Summary of M-13 Rev. 66 Changes

Dean Manno
SOS-Joint meeting
September 6th, 2018

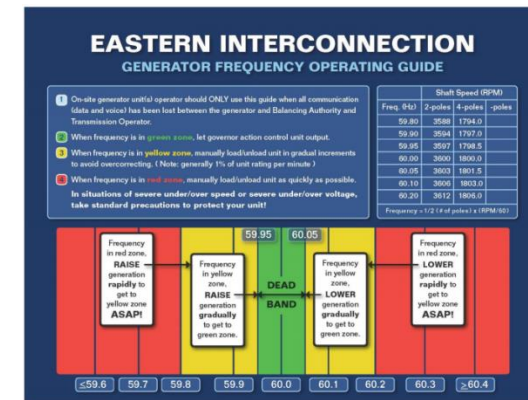
- Re-format – remove table and present actions in “PJM Actions” / “Member Actions” format to match rest of manual
- Subsection for Physical Attack
- Subsection for Cyber Attack against PJM
 - Loss of ICCP/EMS
 - Loss of internet
 - Loss of telecommunications
- New Subsection for Cyber Attack against member company (GO/TO)
- New Subsection for HEMP attack

- Section 4.1 deleted Exhibit 4 table
 - Former Exhibits 5 through 14 renumbered accordingly
 - Former Exhibit 4 content regarding “Elevated Threat Alert” reformatted in section 4.1 as a list of “PJM Actions” and “PJM Member Actions”
